UNITED STATES PATENT AND TRADEMARK OFFICE

10/567,985

Office Action Summary	Application No. 10/567,985	Applicant(s) HORIKE, MASAO	
	Examiner ANDREW T. KIRSCH	Art Unit 4159

DETAILED ACTION

Figs. 1-4 of U.S. Patent No. 4,796,770 (Begley hereinafter)

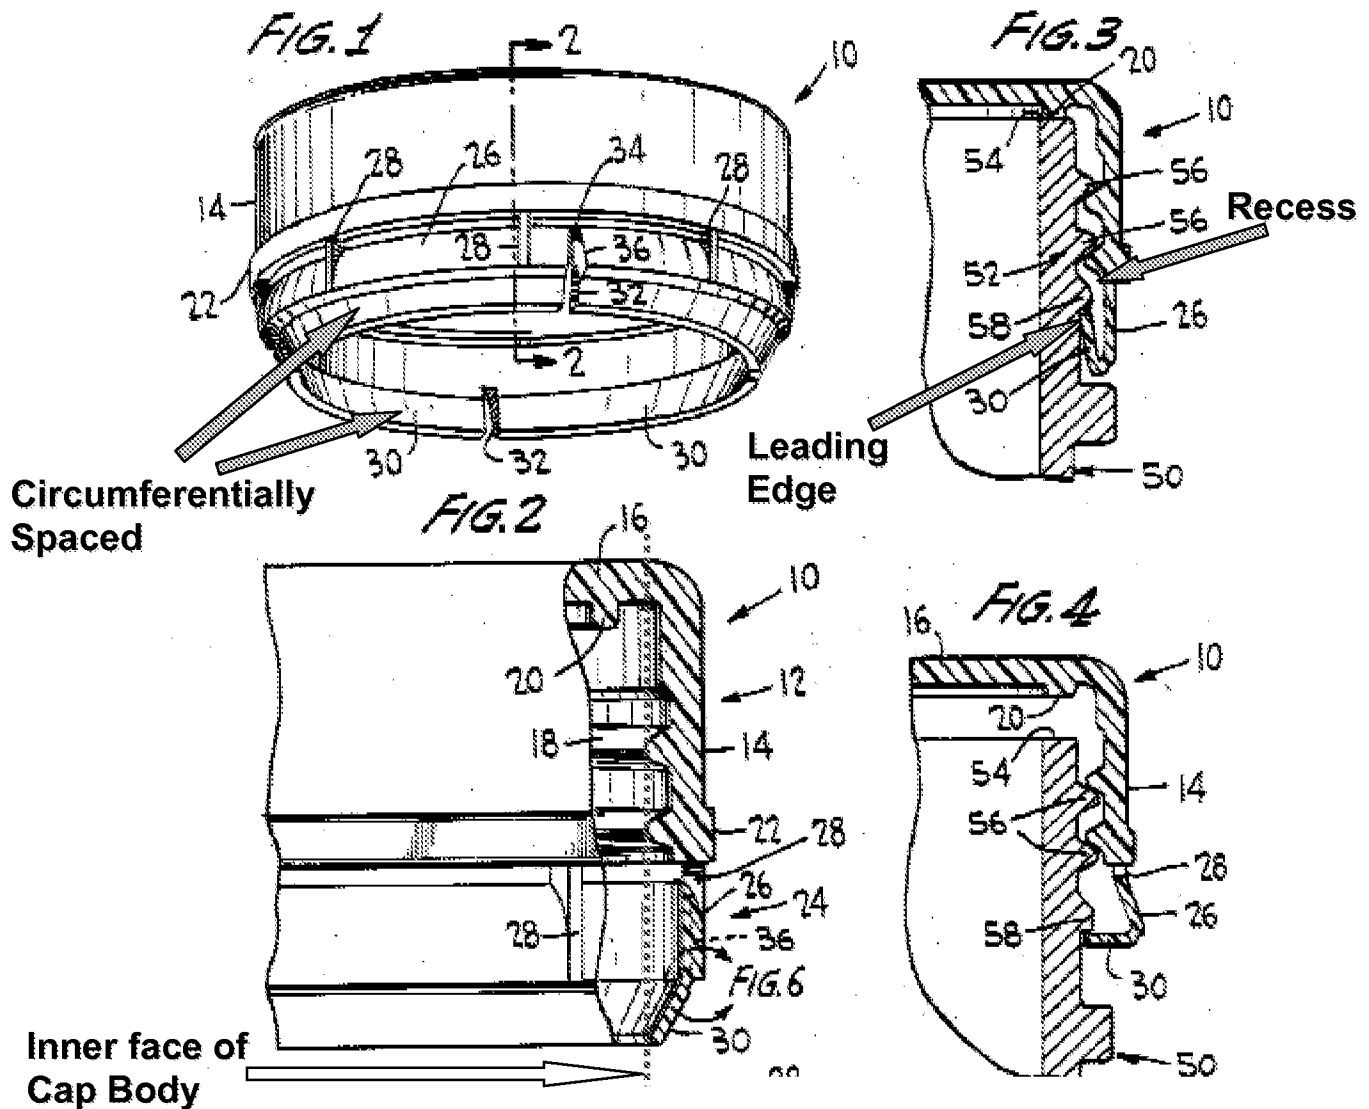
5. In re claim 1, with reference to Figs. 1-4 below, Begley discloses:

A container cap comprising a crown-shaped cap body (12) to be screwed onto a container and cap opening proof indication means (24) formed provided at a lower edge (14) of said cap body (12) and having no part left on a neck part of said container after said cap opens said container (column 4, lines 25-33), characterized in that said cap opening proof indication means comprises a plurality of indication pieces (26, 30) extending from said lower edge of said cap body and a bridge (28) to join the adjacent indication pieces and to be broken due to relative displacement of said adjacent indication pieces when said cap should open said container and a flap (30) provided at a portion of at least one of said adjacent indication pieces in a manner where said flap is able to be bended (col. 4, line 15) and having a leading edge (see Fig. 3) to be engaged with a protrusion stripe engagement portion (58) on a lower portion of said neck part of said container and in that said indication piece adjacent to said indication piece with said flap is provided with flap protrusion prevention to prevent said flap developed when said cap opens said container from protruding from an inner face of said cap body (see Fig. 2).

6. Note that the closure of Begley inherently includes protrusion prevention in the that initial biasing of the flaps (30) as seen in Fig. 2 prevent them from protruding from an inner face of the cap body. Begley mentions that after the first opening of the closure, they remain in the non-protruding condition during subsequent resealing (column 4, lines 25-40).

7. In re claim 2, with reference to Figs. 1-4 above, Begley discloses the claimed invention including wherein said flap protrusion prevention is so formed as to prevent said leading edge (see Fig. 3 above) of said flap. It can clearly be seen that the inherent prevention due to initial biasing (described above) prevents the leading edge of the flap, as the leading edge is attached to the biased flap (30).

8. In re claim 3, with reference to Figs. 1-4 above, Begley discloses the claimed invention including wherein said indication piece (26) with said flap (30) and said indication piece (26) adjacent to said former indication piece form one indication means unit and the adjacent indication means units are provided in a manner spaced circumferentially (see Fig. 1 above).

9. In re claim 4, with reference to Figs. 1-4 above, Begley discloses the claimed invention including wherein said indication piece (26) adjacent to said indication piece with said flap (30) is disposed on both sides of said indication piece with said flap (30) (see Fig. 1).

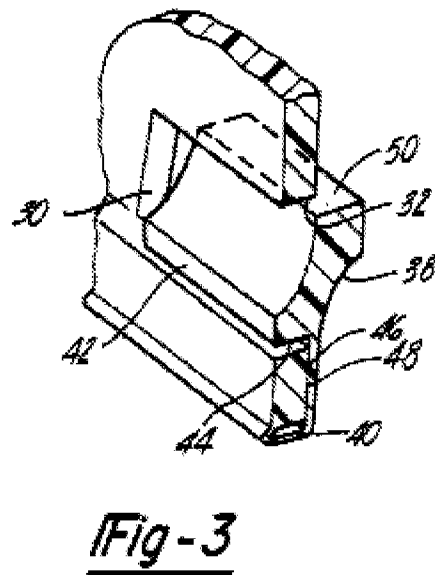
15. However, with reference to Figs. 1-3 below, Wright et al. discloses a tamper evident closure system which includes a small width formation portions (See Fig. 3) formed on the opposite faces of indication pieces (26, 40).

16. Therefore, it would have been obvious to one of ordinary skill in the art at the time the invention was made to have modified the closure structure of Begley utilizing the teaching of Wright et al. for the purposes of maintaining the flap in an outward

orientation. Such a modification would have allowed for easier clearing of the threads and other neck formations on the container during subsequent resealing of the container. Although the tamper evident structure of Wright et al. is substantially different in that it is formed for maintaining the flaps in the pre-tamper condition, it would have required only routine skill in the art to modify the structure to maintain the flaps in the open, post-tampering position in a manner analogous to that of the instant application.

17. In re claim 6, with reference to the Figures above, Begley in view of Wright et al. discloses the claimed invention including wherein said small width formation portion of said flap protrusion prevention comprises a thinner piece (40) extending integrally from the opposite inner sides of said both side indication pieces (38, 40).

18. In re claim 7, with reference to the Figures above, Begley in view of Wright et al. discloses the claimed invention including wherein said small width formation portion (see Fig. 3) of said flap protrusion prevention has an inclination face (34, 48) inclined downward and outward and said corresponding flap has an inclination face (44, 46) to be slipperily moved along said inclination face of said flap protrusion prevention.

Figs. 5 and 7 of U.S. Patent No. 4,579,456 (Kusz hereinafter)

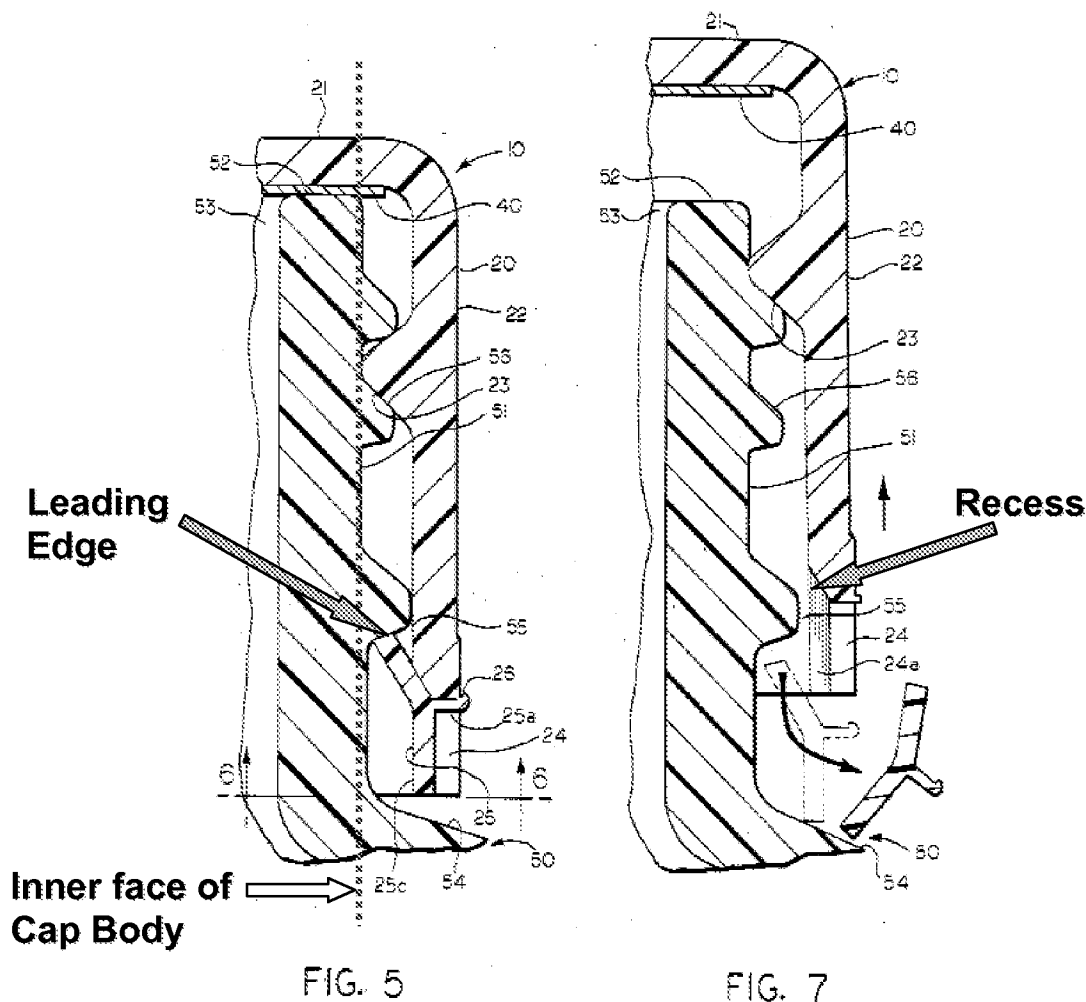
22. However, with reference to Figs. 5 and 7 below, Kusz discloses a tamper evident closure for a container in which the flap is contained in an analogous recess and never protrudes from the inner surface of the cap while in the bended configuration.

23. Therefore, it would have been obvious to one of ordinary skill in the art at the time the invention was made to have modified the tamper evident closure of Begley with the recess orientation and flap location of Kusz. Such a modification would have allowed for simpler initial closing of the closure, as the Begley reference mentions that the leading edge slides over the bead and neck formations (col. 3, lines 54-56), whereas the flap of Kusz deflected inwards prior to the first sealing (col. 4, lines 24-30).
